**GENOA CHARTER TOWNSHIP
PLANNING COMMISSION PUBLIC HEARING
NOVEMBER 13, 2017
MONDAY
6:30 P.M.
AGENDA**

Attention:	Kelly Van Marter, AICP Planning Director and Assistant Township Manager
Subject:	Brighton Church of the Nazarene – Site Plan Amendment (Review #2)
Location:	7669 Brighton Road – northwest corner of Brighton and Aljoann Roads
Zoning:	SR Suburban Residential

Request to Amend the Approved Site Plan

SCALE: 1" = 40'
JOB NO.: 17-393
DATE: 10-4-17
SHEET NO.: 3

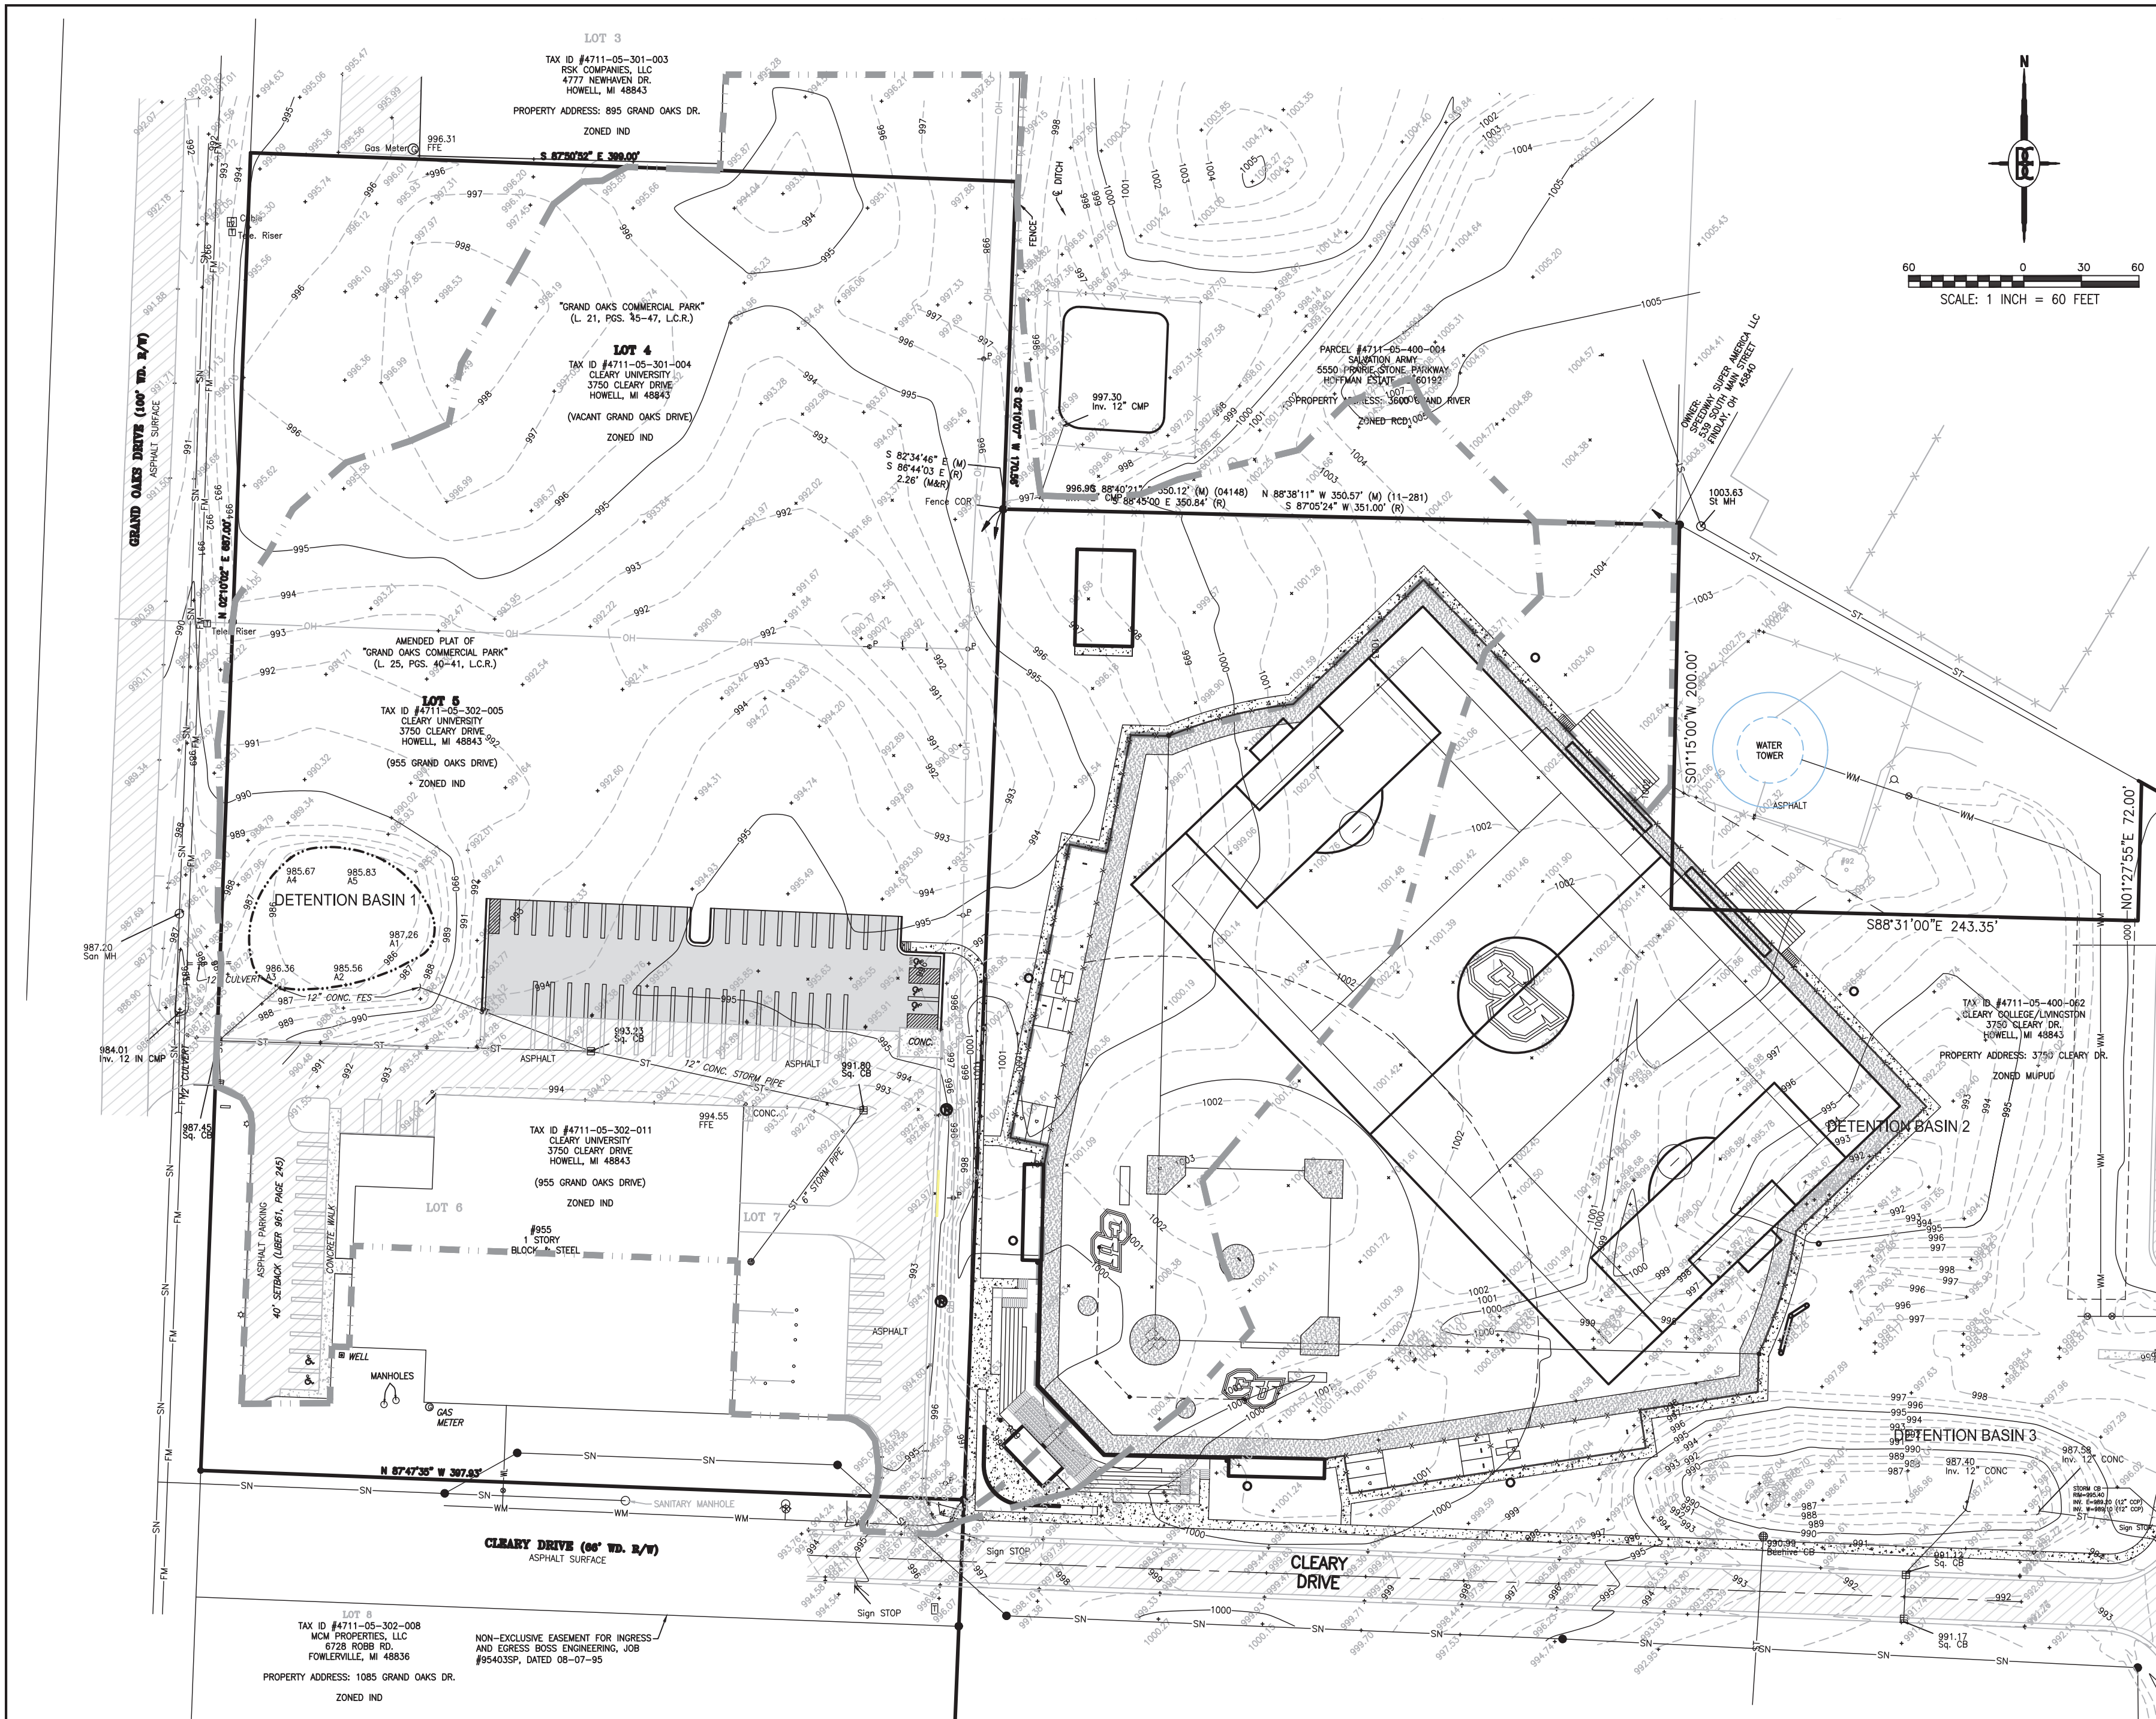
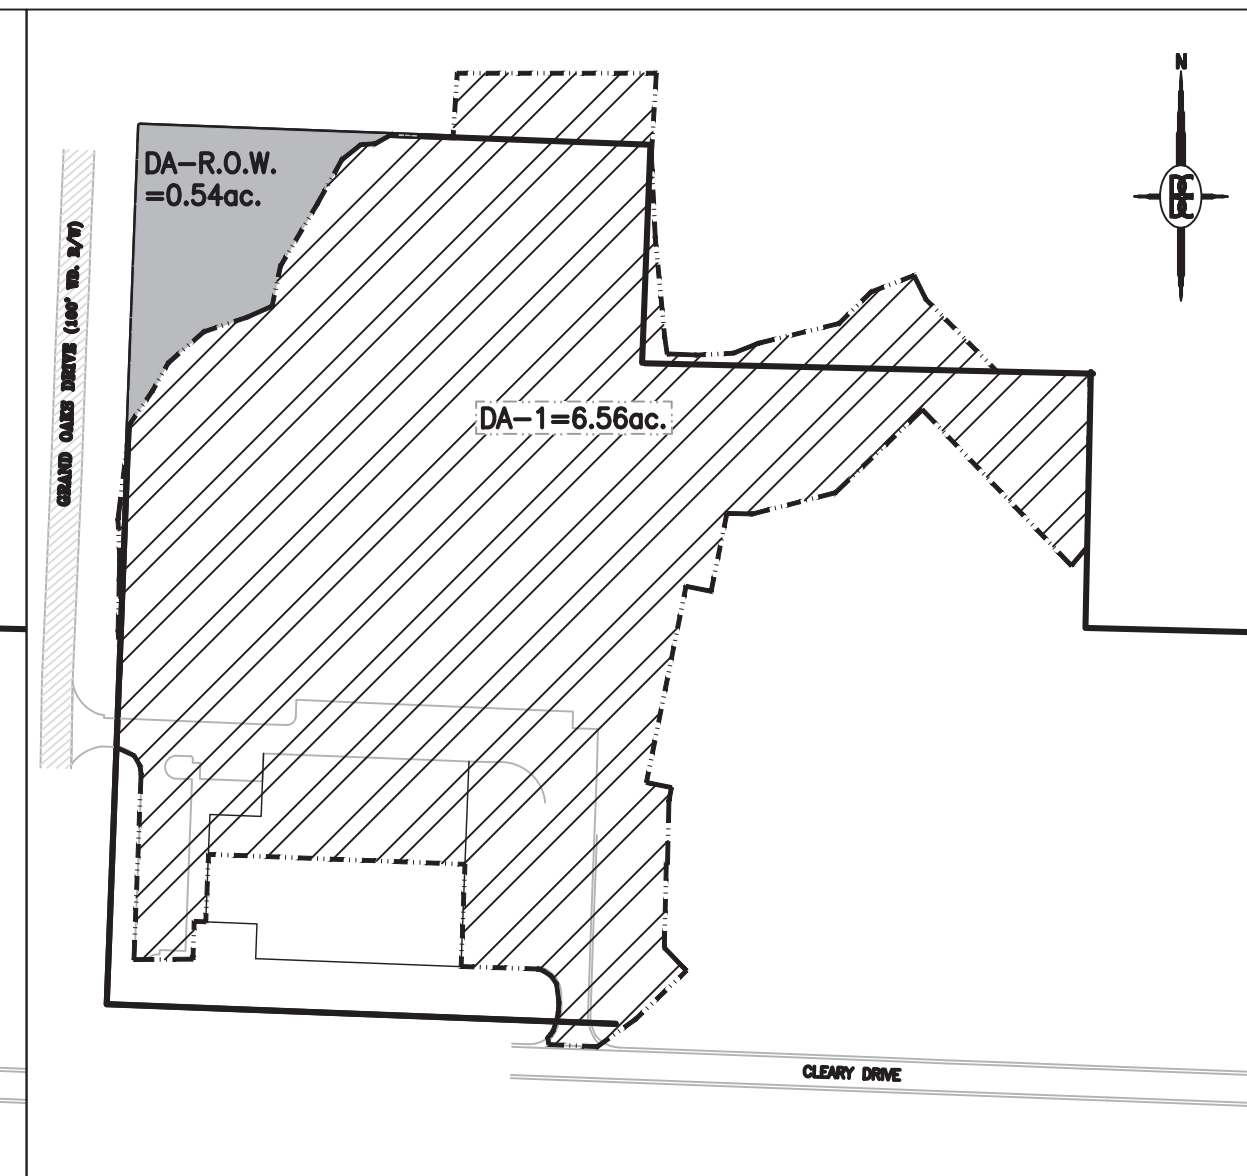
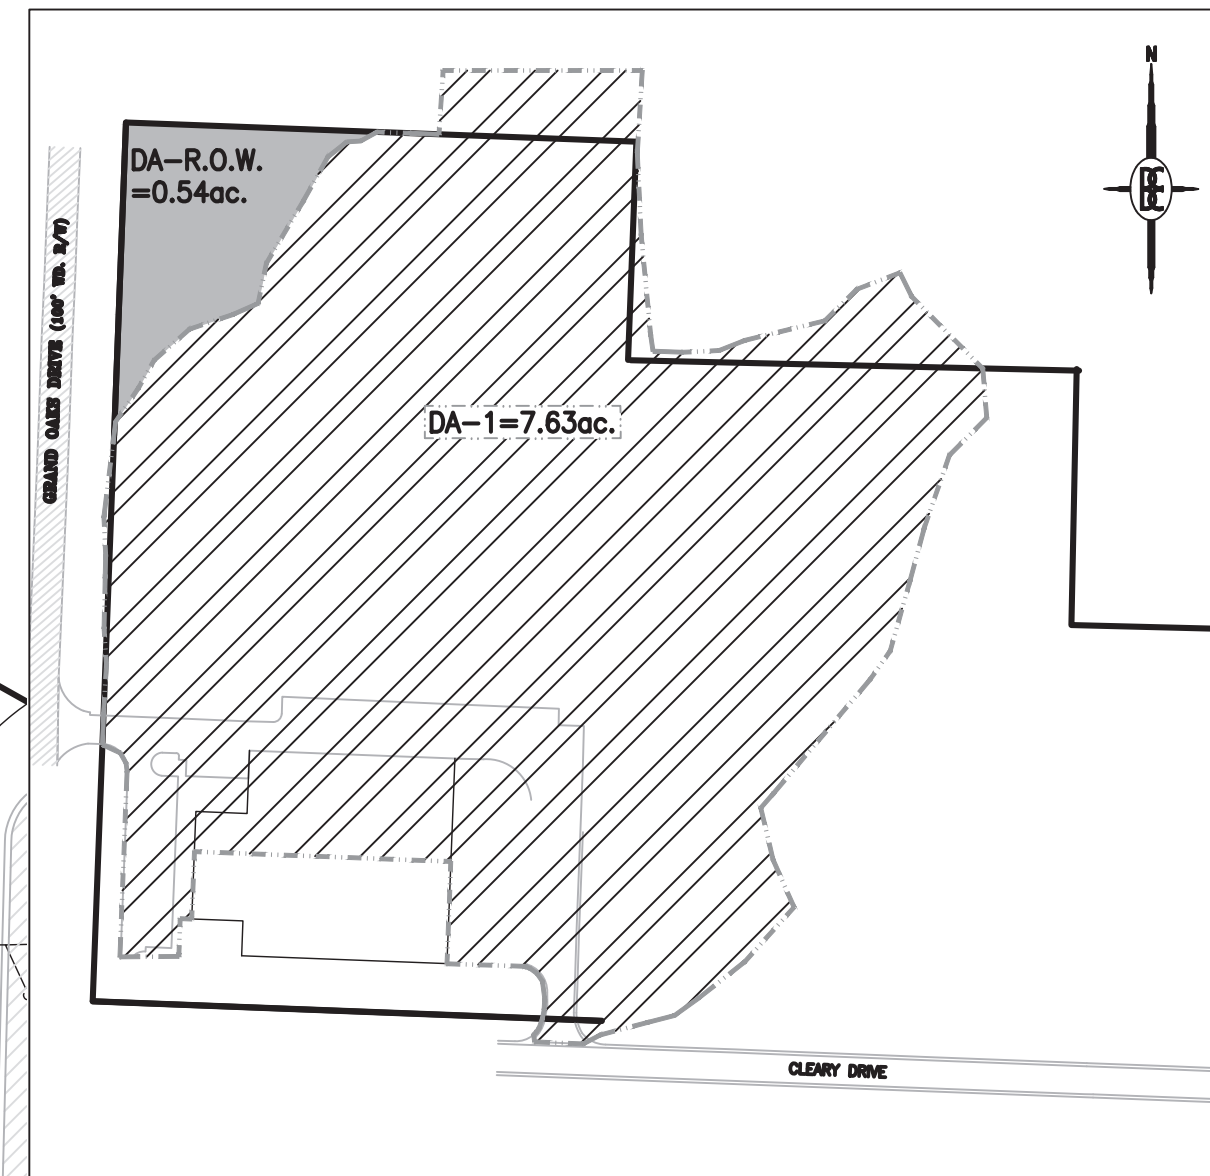
- 3. Parking.** Section 14.04 requires 1 parking space for each 6' of bleachers. Based on the information provided on Sheet 3, 131 parking spaces are required. The proposal includes a combination of existing and proposed parking spaces that add up to 131 spaces, including the 5 required barrier-free spaces.

5. **(CORRECTED)** The location of a key box (Knox Box) shall be indicated on future submittals. The Knox box will be located adjacent to the front door of the structure. **(Note on Sheet 3 reflects the intent to install a knox box on the structure.)**
IFC 506.1
